# SERVICE LETTER

**No. 619**

Subject: Inspection of Piper part number 83302-13 Retainer Spring

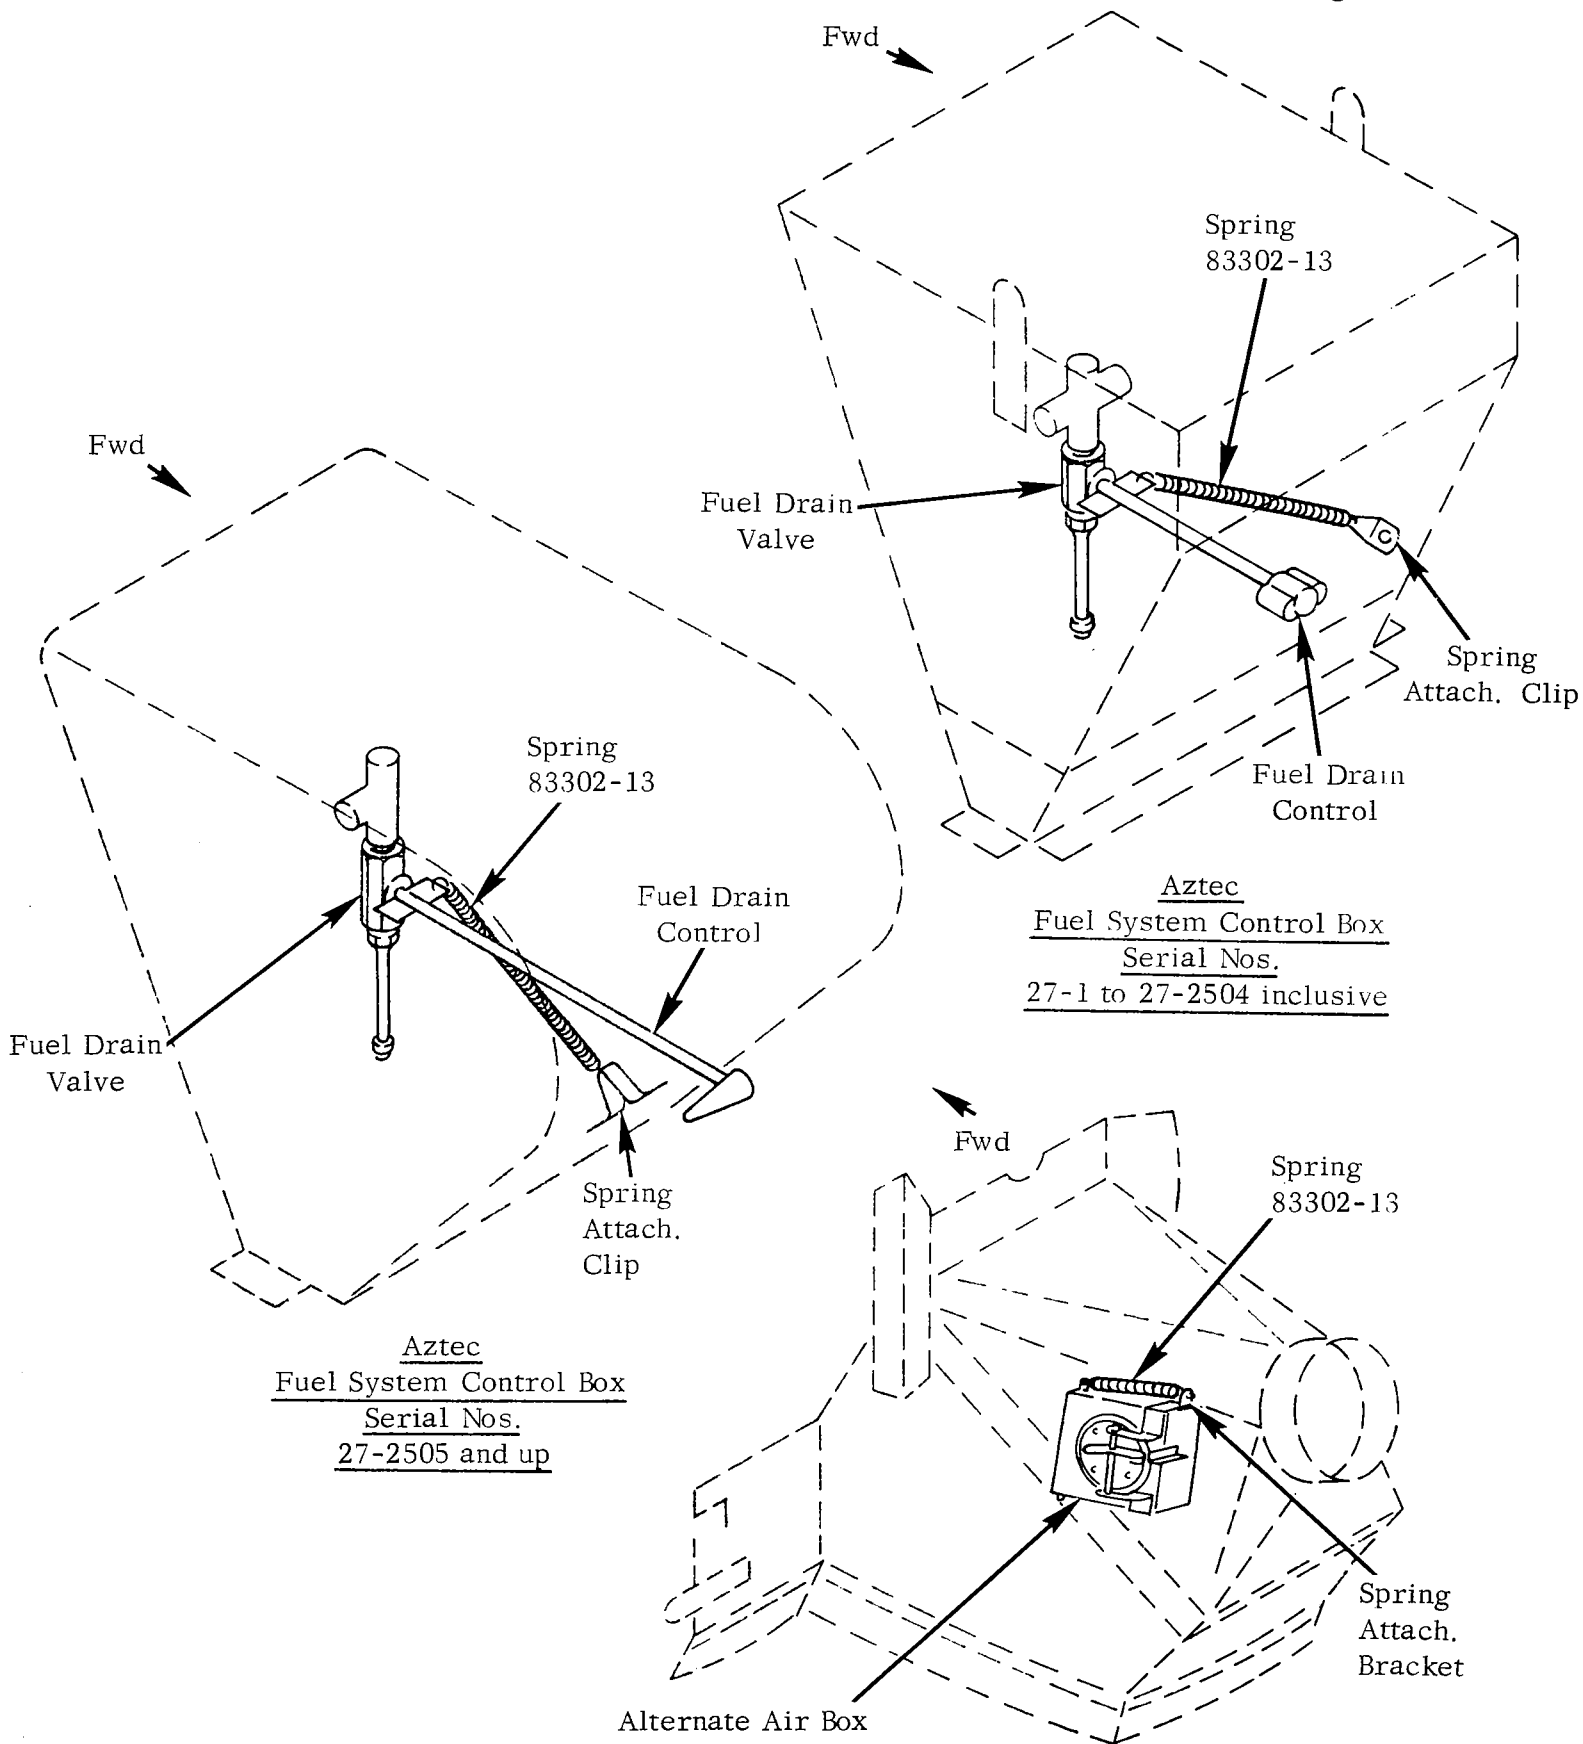
Recent reports received from the field describe premature failures of the above referenced springs, occurring on aircraft with relatively low time in operation. The reports indicated that the springs were too brittle for proper function; a subsequent check of existing factory stock of the above referenced spring confirmed the assumption that the springs are subject to "hydrogen embrittlement", which occurs during the manufacturing process and manifests itself in springs which are too brittle - causing premature breakage.

This Service Letter requests the replacement of the subject spring as used in the above described configuration to insure that any defective springs installed in the above referenced aircraft are removed from service.

1. Gain access to the Aztec Fuel Control Box and Navajo Air Filter Plenum Assembly; refer to attached sketch for a general illustration.
2. Remove the spring from the Aztec Fuel Drain Control Stem and Navajo Alternate Air Box Door Assembly and install replacement spring (see Material Required, below).
3. Make appropriate log book entry.

1. Aztec Fuel Control Box: One (1) each (per aircraft) Retainer Spring, part number 83302-13.
2. Navajo Alternate Air Box Door: One (1) each (per Alternate Air Box) Retainer Spring, part number 83302-13.
